June 2, 2022
PanGEO Project No. 21-094

Subject: Supplemental Report - Landslide Hazard Review
 Carbon Treatment Facilities
 Bell Hill and Hoffman Hill, DuPont, Washington

Bell Hill Site – LiDAR Imagery

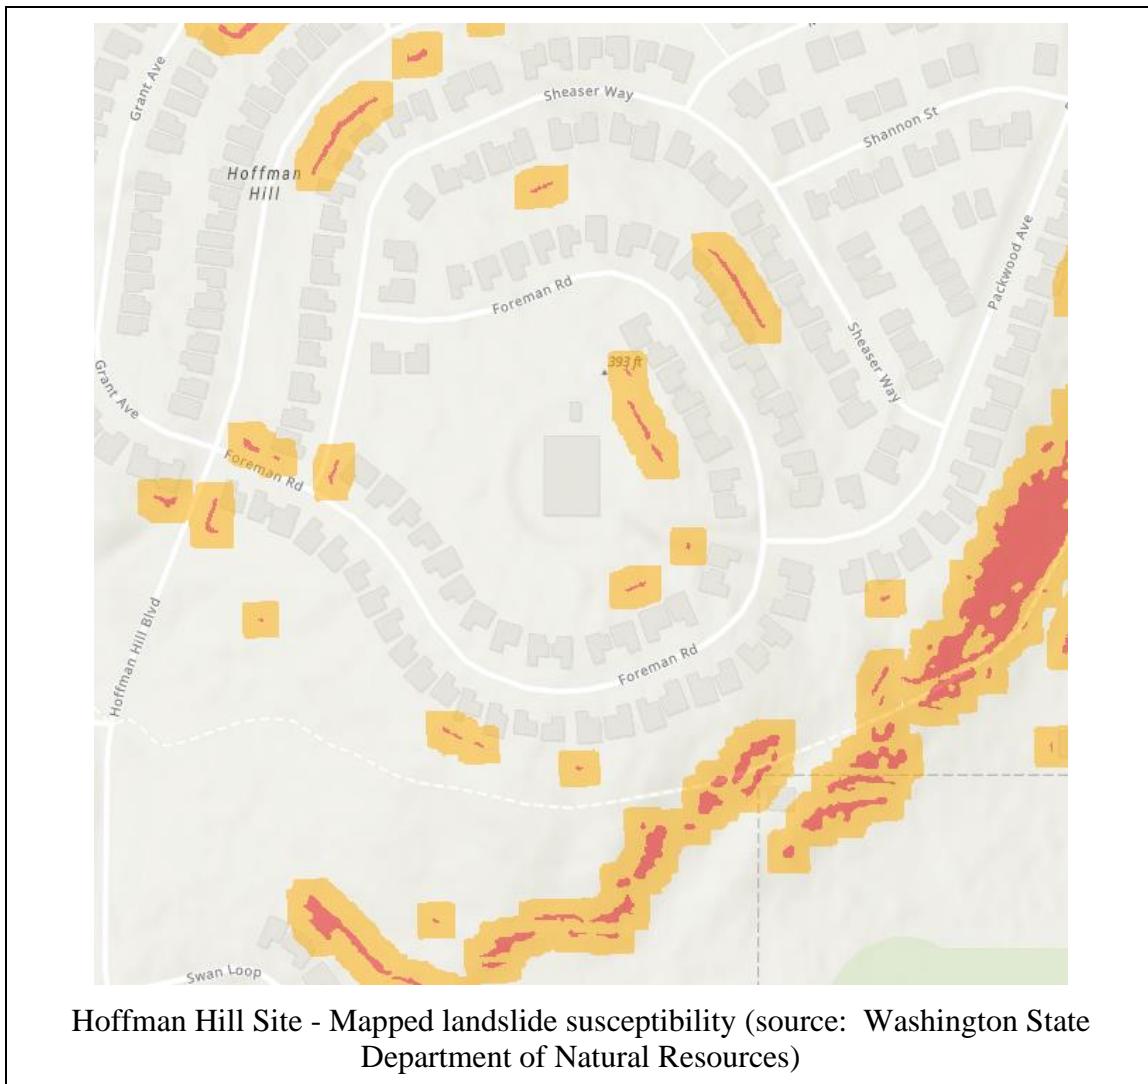
The existing slope adjacent to the construction area is between 40 and 50% gradient and is taller than 10 feet. However, based on the review of LiDAR image (below), we believe that the slope was created by previous grading activities associated with the construction of the existing facility. Since the slope immediately adjacent to the proposed construction area was graded to no steeper than 2H:1V (i.e., 50% slope), which is consistent with the current standard of practice for competent soils, the slope should not be considered a landslide hazard area.

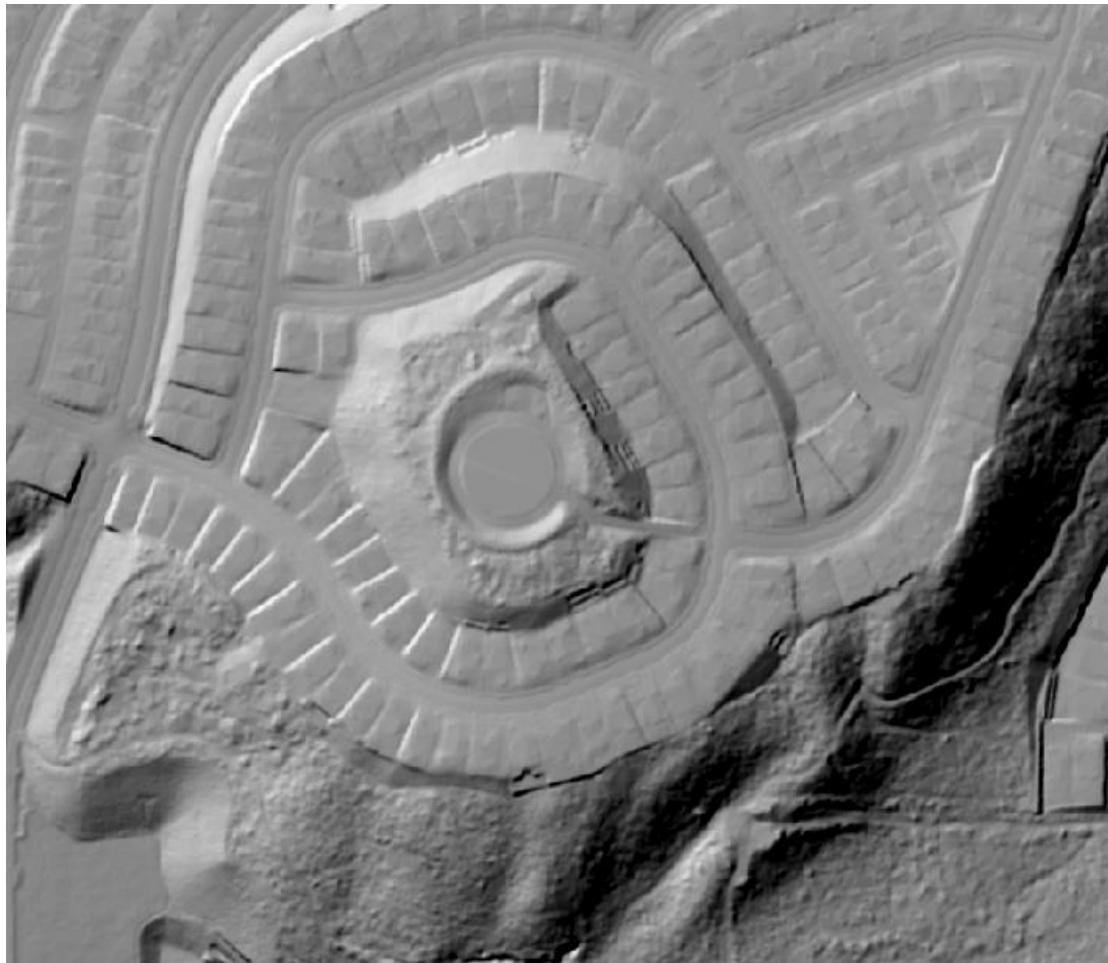
According to the DNR Website, the area located downslope of the proposed Carbon Treatment facility at Hoffman Hill is mapped as susceptible to shallow instabilities (i.e., surficial sloughing and erosions), but not at risk of deep-seated landslides. No signs of landslide scars are located in the area

The area of the proposed construction is not mapped as susceptible to slope instabilities.

The mapped surficial landslide risk located downslope of the construction area is likely due to the steepness of the slope. Any surficial instabilities on the slope should not extend into the proposed construction area.
